SUBJECT: Forwards response to NRC 800223 request re LWR primary  
 coolant sys pressure isolation valves.No mods to OL  
 necessary.

DUKE POWER COMPANY  
OCONEE NUCLEAR STATION

Response to Request for Information  
NRC Letter Dated February 23, 1980

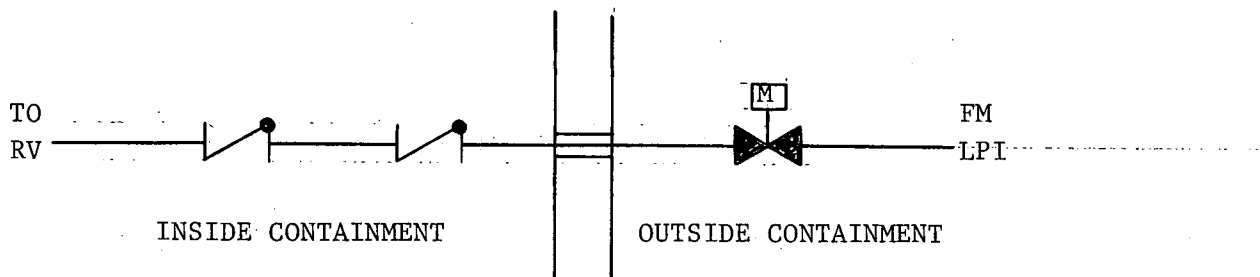
Describe the valve configuration at your plant and indicate if an Event V isolation valve configuration exists within the Class I boundary of the high pressure piping connecting PCS piping to low pressure system piping; e.g., (1) two check valves in series, or (2) two check valves in series with a MOV.

If either of the above Event V configurations exist at your facility, indicate whether continuous surveillance or periodic tests are being accomplished on such valves to ensure integrity. Also indicate whether valves have been known, or found, to lack integrity;

If either of the above Event V configurations exist at your facility, indicate

whether plant procedures should be revised or if plant modifications should be made to increase reliability.

The piping configuration at Oconee which most closely approximates Figure 1 is as follows:

The MOV is normally closed except during quarterly testing and upon unit shut-down when the system is in use for decay heat removal.

The above Event V configurations as contained in Figure 1 do not exist at Oconee. However, during quarterly testing of the MOV, the valve is cycled and system lineup of Figure 1 would exist. The MOV is never locked open.

For these valves in question, there has been no evidence of lack of integrity.

The above Event V configurations as contained in Figure 1, do not exist at Oconee. However, during quarterly periodic testing, the MOV in question is cycled. To prevent the possibility of over pressurizing the low pressure piping, Duke is modifying the inservice testing program to require this MOV to be tested during periods of cold shutdown.
